Addendum to Supporting Planning Statement
following revisions for proposed demolition of
existing redundant mill premises and the erection
of 55 dwellings with associated parking and open
space at Cellars Clough Mills, Manchester Road,
Marsden, Huddersfield, HD7 6LY

SHF.1330.001. P.R.003

Project:	Addendum to Supporting Planning Statement
For:	Proposed demolition of existing redundant mill premises and the erection of 55 dwellings with associated parking and open space at Cellars Clough Mills, Manchester Road, Marsden, Huddersfield, HD7 6LY
Status:	Report for submission to local planning authority
Date:	23.11.17
Author:	David Storrie Dip TP, MRTPI Director of Planning
Reviewer:	Matt Travis, Director

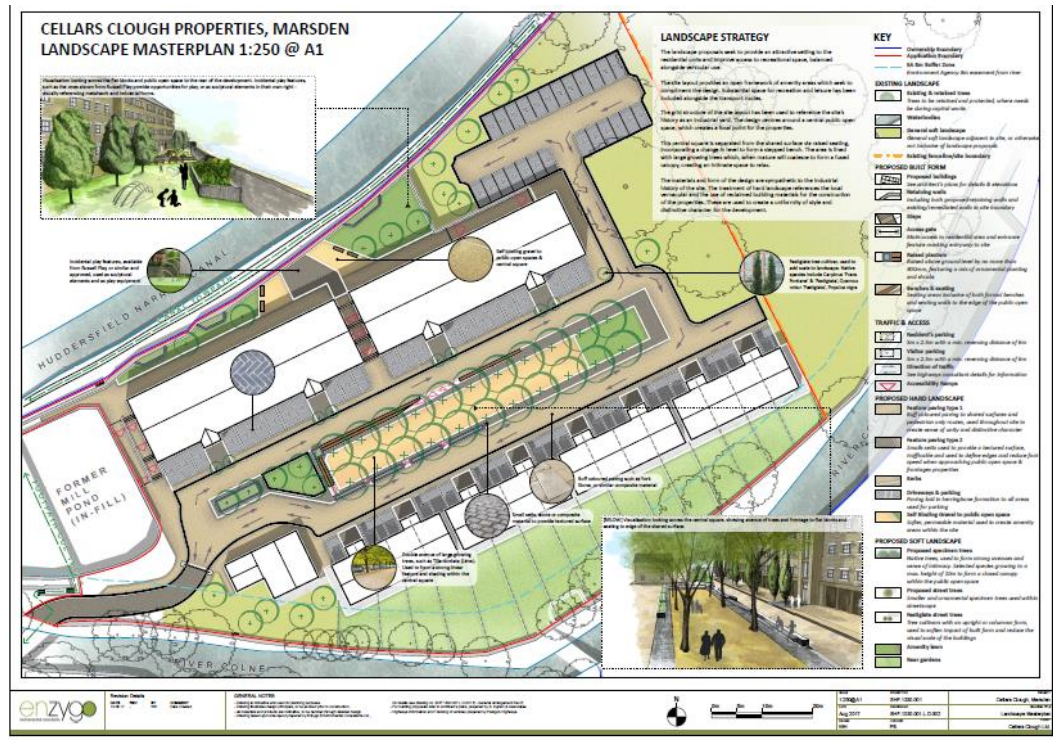
- 1.1.3 The layout and form of development have been revised to provide two blocks of apartments adjacent to the canal to reflect the massing of the existing mill with three storey dwellings in a linear form adjacent to the river. This provides a much better form of development and provides an opportunity to provide appropriate landscaping between the two building forms. The original and revised schemes are set out below for comparison.

2.1.1 As stated above, the form of development has been amended to provide a more sympathetic form taking account of the industrial heritage of the site. The intention is to use reclaimed stone from the demolished mill.
